5422-AuroraWind-Epsilon-Review-190222.docx

**Subject: Sound Level Analysis Review
 Proposed Aurora Wind Project – Williams County, North Dakota**

63 PU-18-352 Filed 02/22/2019 Pages: 6
 Sound analysis report
 Aurora Wind Project, LLC

Screenshot from Google Earth of Receptor V 8:

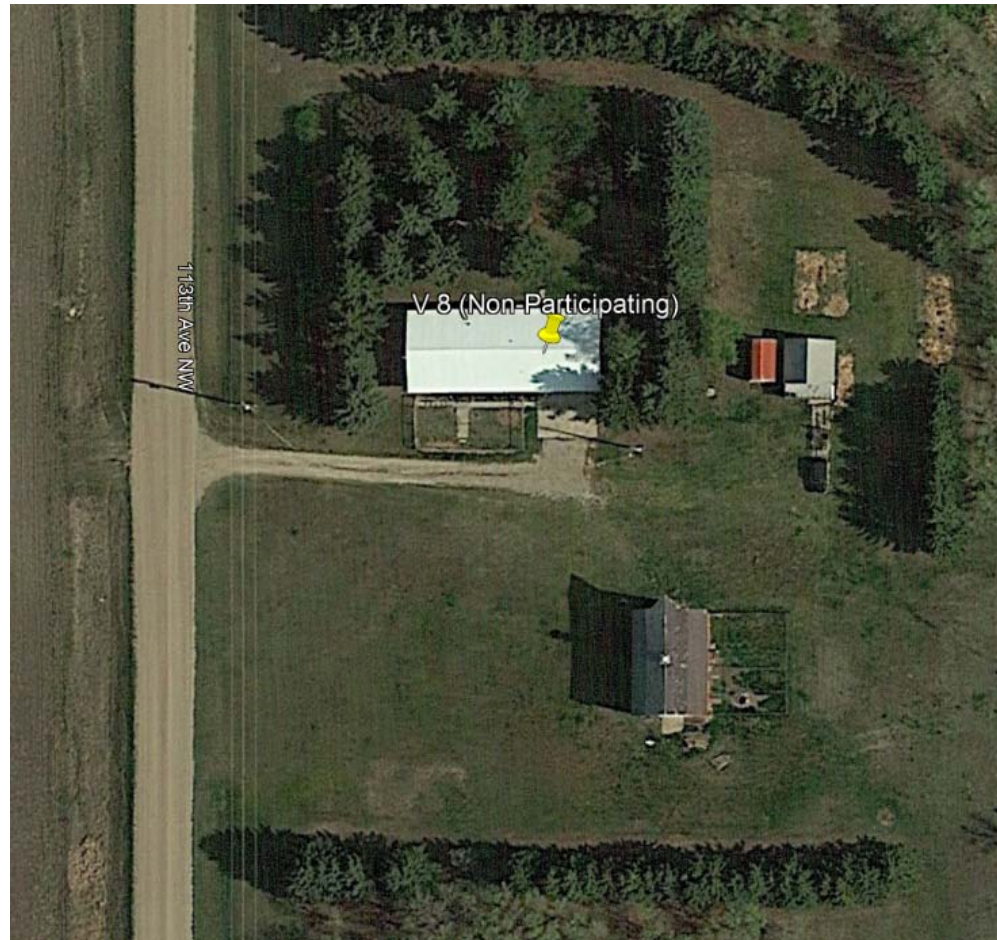
Although in the Sound Analysis section of the report it states that the Commission has a wind turbine sound level limit of 50 dBA within 100 feet of an inhabited residence or community building, only center points of structures have been modeled. A detailed review of all receptor locations was not conducted, but Google Earth imagery for one receptor point (labeled as "V 8") is shown on the following page. Of the structures shown, the modeled location is likely a home although "Street View" was not available for this location to confirm this assumption.

Due to the modeling receptor location, sound levels within 100 feet of inhabited residences in the direction of the wind closest wind turbine would likely be slightly higher than what is presented in the WindPRO output. Although discrete points 100 feet from the homes were not modeled, compliance with respect to 50 dBA at this distance was evaluated by Tradewind. Table 2 of the Sound Analysis presents the distance from the receptor (assumed approximate center point of the home) to 50 dBA for the worst-case scenario (GE 2.5-127). The minimum distance presented is 253 feet. This distance (in meters) is directly output by WindPRO as shown in the provided outputs labeled as "Distance to noise demand". 253 feet (77 meters) is greater than the distance from the center point of the home to the façade of the home plus 100 feet; therefore, this location is in compliance with the sound level limit. Although this approach differs from Epsilon's typical approach for evaluating

this type of limit, the modeling analysis demonstrates compliance with the 50 dBA limit 100 feet from an inhabited residence for all turbine models presented.
